PREVOST

**SAFETY
RECALL**

Sr05-07

DATE : March 2005	SECTION : 14
SUBJECT : INSPECTION & REPLACEMENT OF POWER STEERING PRESSURE HOSE

FIGURE 1: INSTALLATION OF NYLON TIES (TYPICAL)

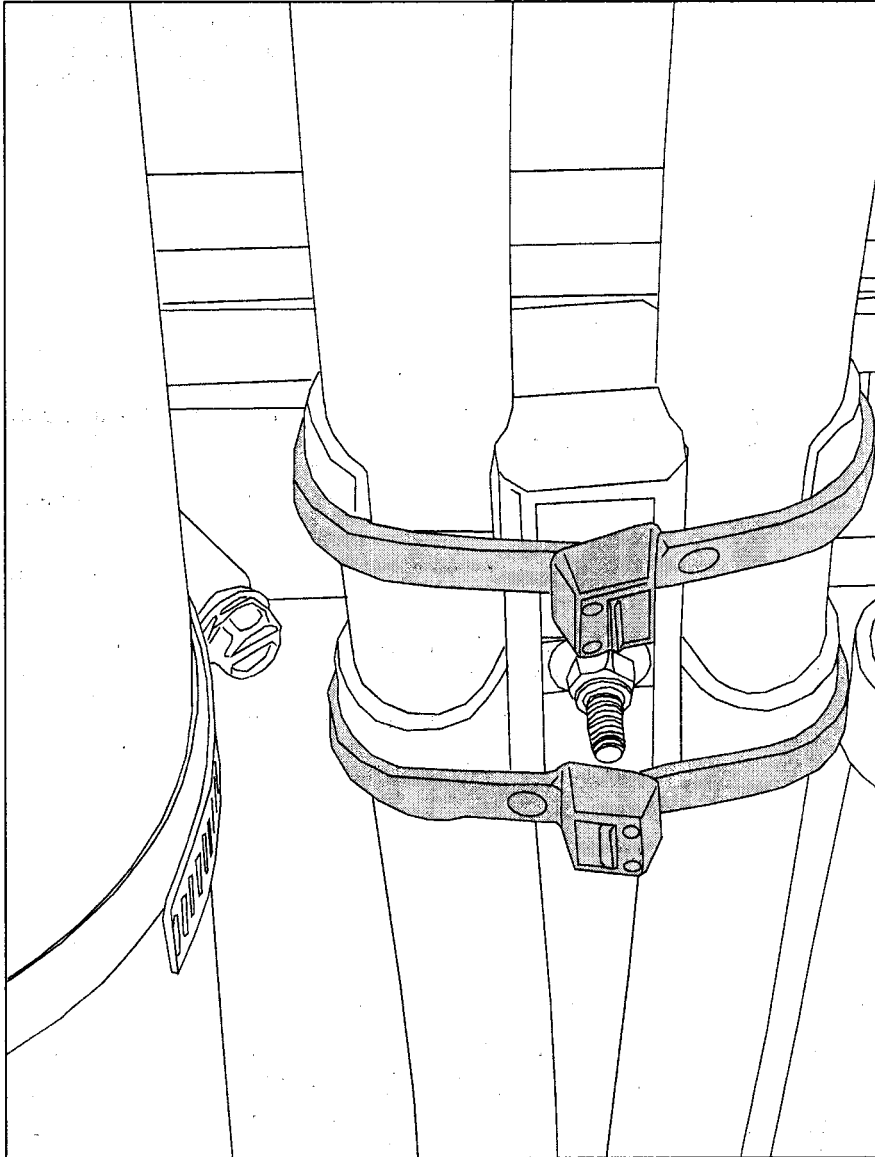
1. Fix pressure hose to supports using nylon ties (Refer to figure 1).

2. If the pressure hose oozes with oil or premature hose wear has reached the wire reinforcement, replace the entire power steering pressure hose (161164).

FIGURE 2: H3 OR XLII VEHICLES

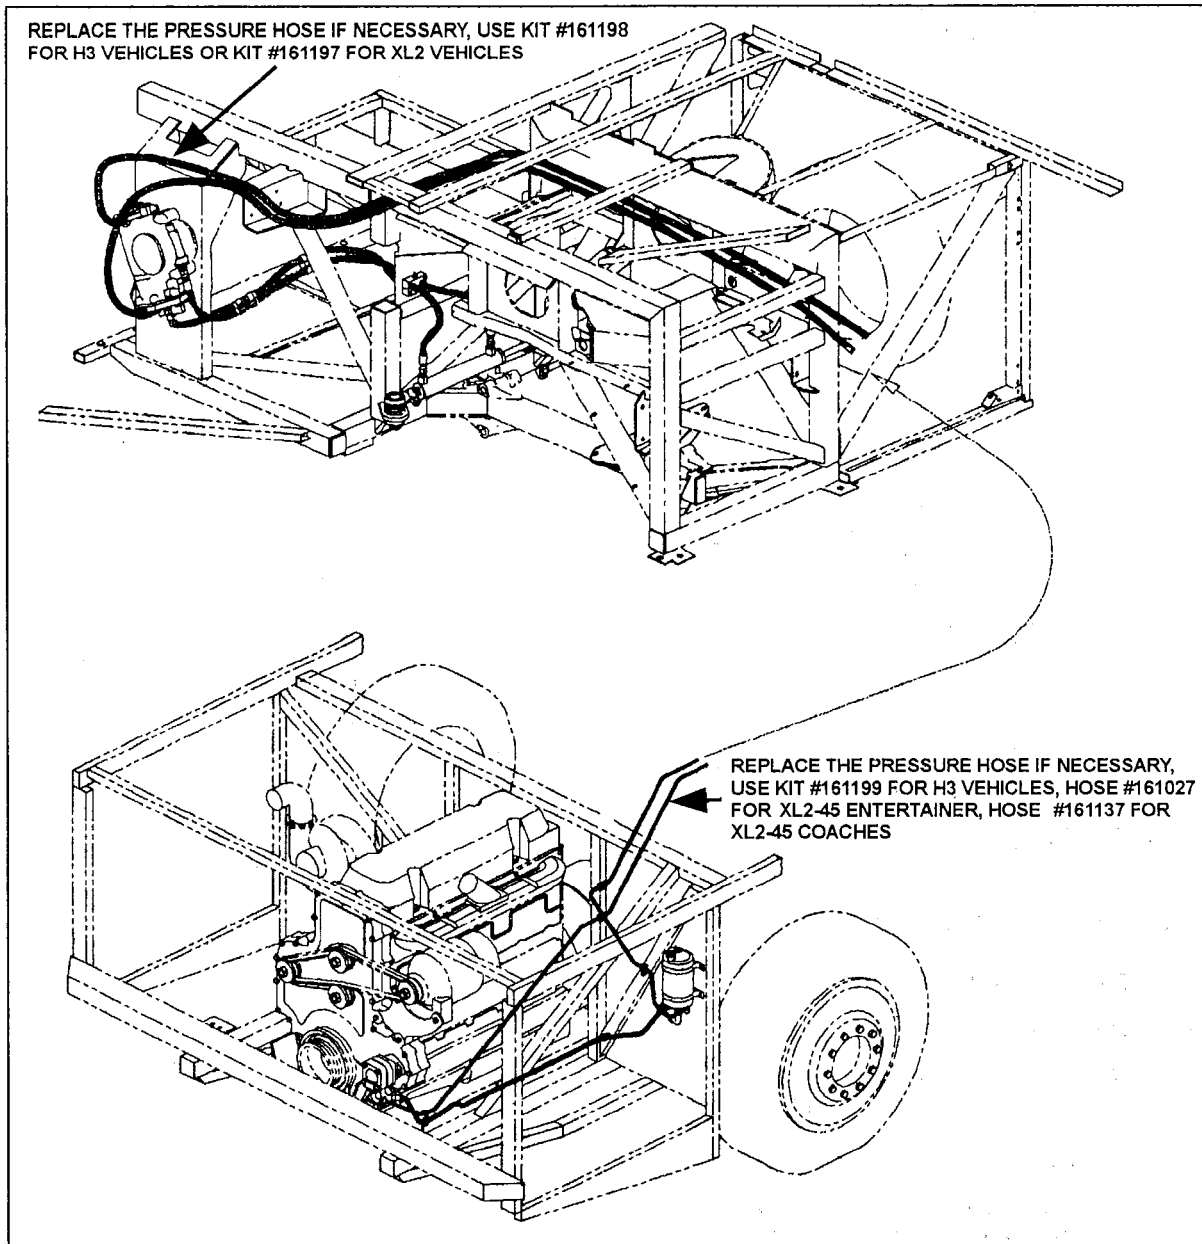
1. Put a container into place below the power steering gear, and then disconnect the pressure hose from the power steering gear. Cover fittings to prevent fluid contamination.
2. Measure the new hose length (161196) supplied in kit #161198. Cut and remove the corresponding length of hose from the installed hose.
3. Install the male connector (501456) to the end of the cut hose.
4. Install the new hose between the male connector and the power steering gear.
5. Bleed air from the system as indicated in section 14 of Maintenance Manual.

1. Open the engine compartment door then put a container into place below the power steering pump, and then disconnect the pressure hose from the power steering pump. Cover fittings to prevent fluid contamination.
2. Measure the new hose length (161194) supplied in kit #161199. Cut and remove the corresponding length of hose from the installed hose.
3. Install the male connector (501456) to the end of the cut hose.
4. Install the new hose between the male connector and the power steering pump.
5. Bleed air from the system as indicated in section 14 of Maintenance Manual.

FIGURE 4: XLII VEHICLES

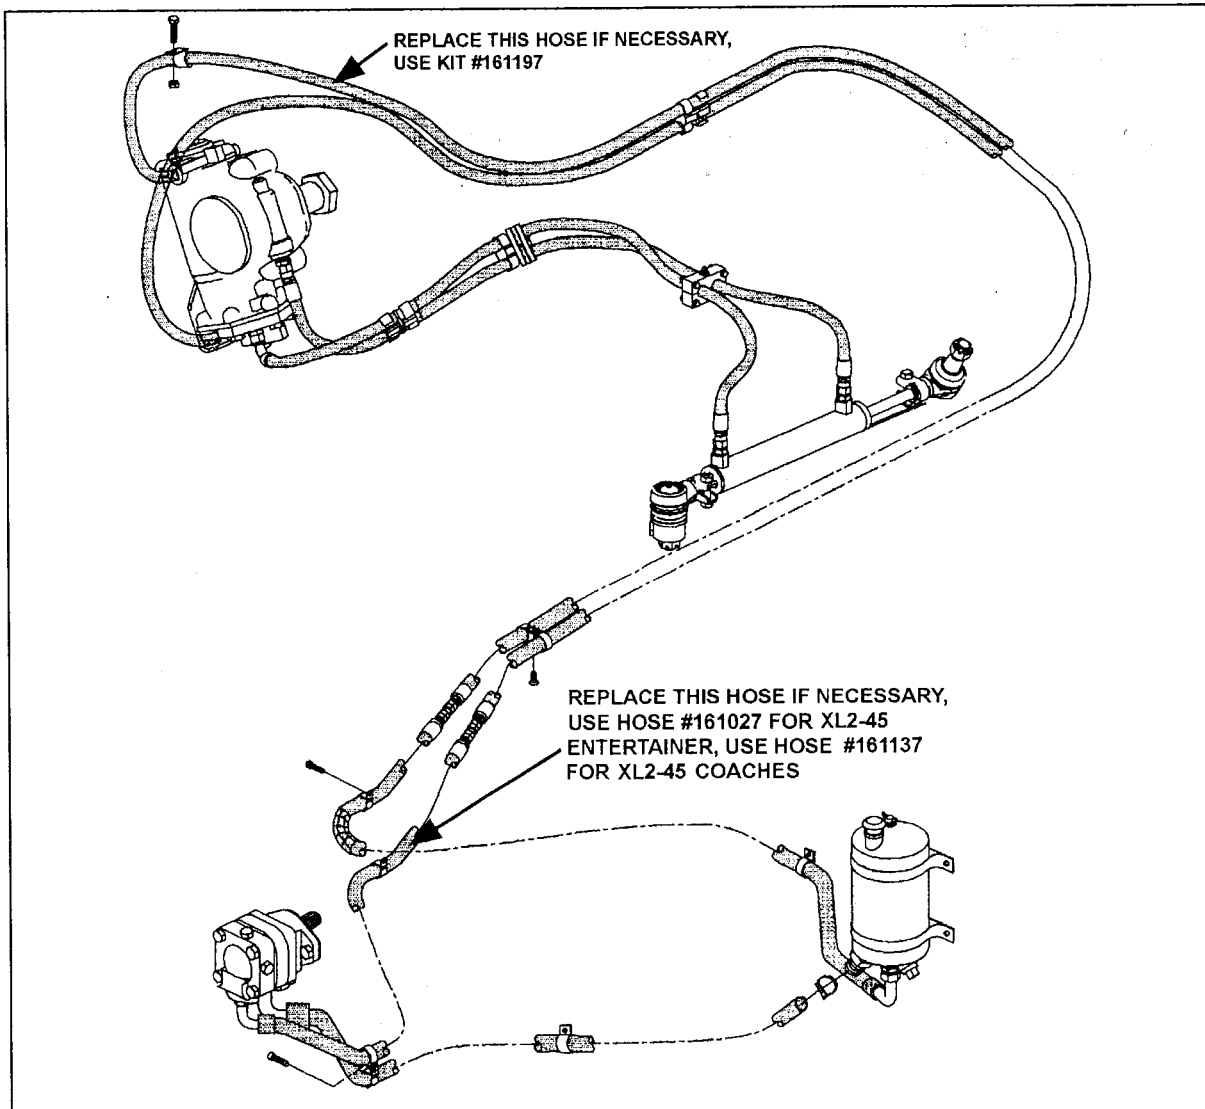
2. Measure the new hose length (161195) supplied in kit #161197. Cut and remove the corresponding length of hose from the installed hose.
3. Install the male connector (501456) to the end of the cut hose.
4. Install the new hose between the male connector and the power steering gear.
5. Bleed air from the system as indicated in section 14 of Maintenance Manual.

1. Open the engine compartment doors then put a container into place below the power steering pump.
2. Disconnect the pressure hose located between the power steering pump and the bulkhead connector. Cover fittings to prevent fluid contamination.
3. Install the new hose (161027 or 161137) between the bulkhead connector and the power steering pump.
4. Bleed air from the system as indicated in section 14 of Maintenance Manual.

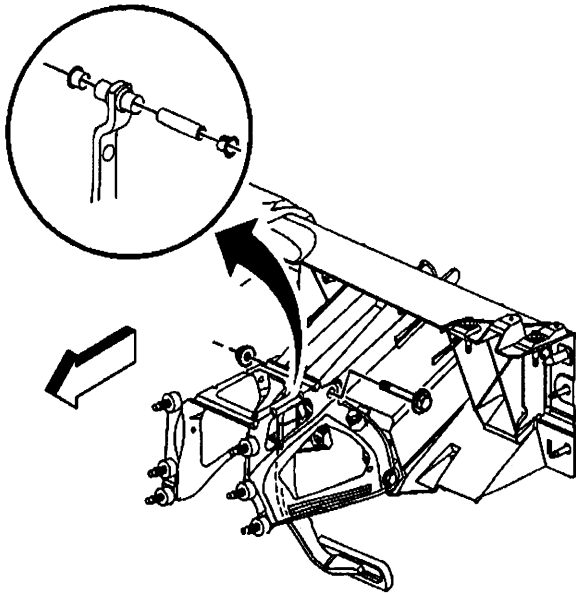
1. Unplug and remove the brake pedal position sensor.
2. Remove the brake pedal pushrod retaining clip from the brake pedal.
3. Remove the brake pedal pushrod and bushing from the brake pedal.
4. Coat the new bushing with white lithium grease (P/N 12345996) before installation.
5. Install a new bushing into the brake pedal pushrod from the outboard side.

Important: This is opposite the way that the original bushing was installed. The retaining flange should be on the retaining clip side of the brake pedal pushrod.

6. Install the brake pedal pushrod and bushing to the brake pedal.
7. Install a new brake pedal pushrod retaining clip to the brake pedal.
8. Install a new brake pedal position sensor.

Tighten the screw to 2.0 N·m (18 lb in).
